Return acknowledgement modification of MicroVent

modification kit 8413122 according to IDM 11/95 Nr. 1 in the following unit.

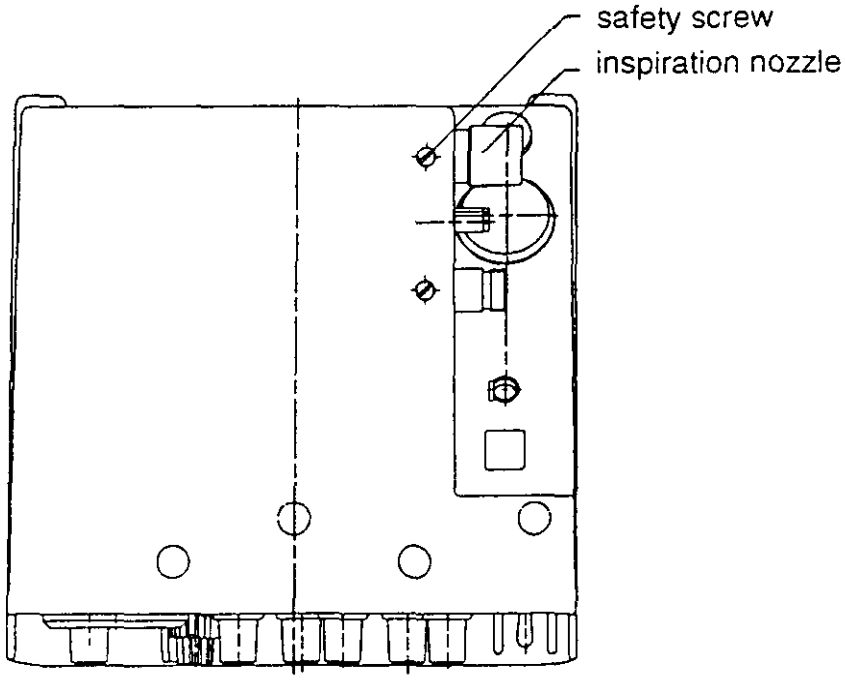
1.) Remove safety screw of inspiration nozzle

2.) Pull inspiration nozzle from the side

3.) Slide the new nozzle 84 13 119 far enough in so that from above it can be lined up with the safety screw which should be screwed back into its former position.
